ADDENDUM

Project: NSP Water main valve installation

Addendum No.: 1

AES Project No.: 23124

Sheet M1.2 Site Utility Plan – Area B

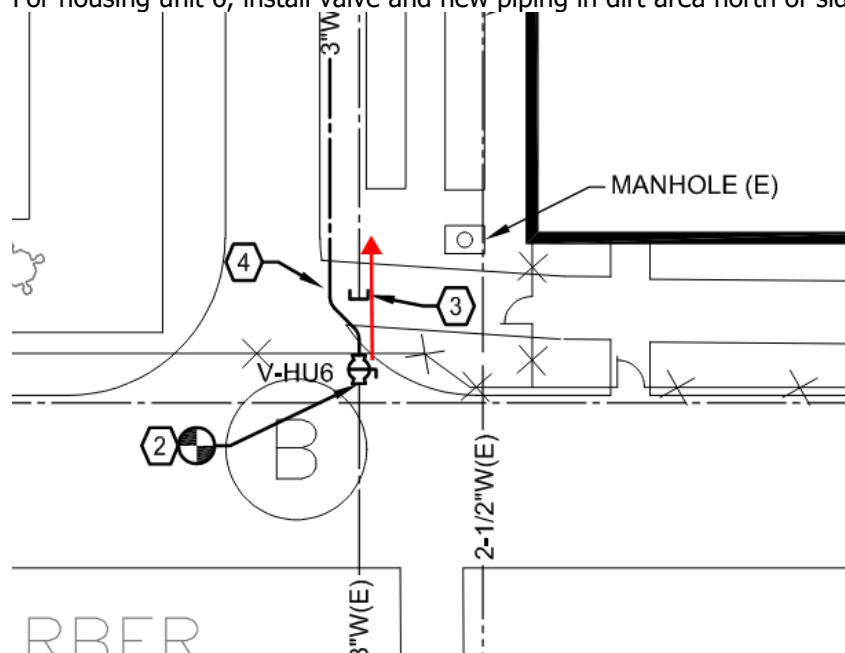
6. For housing unit 6, install valve and new piping in dirt area north of side walk.

7. For housing unit 7-8, install valve and new piping in dirt area north of fence / south of ball field.
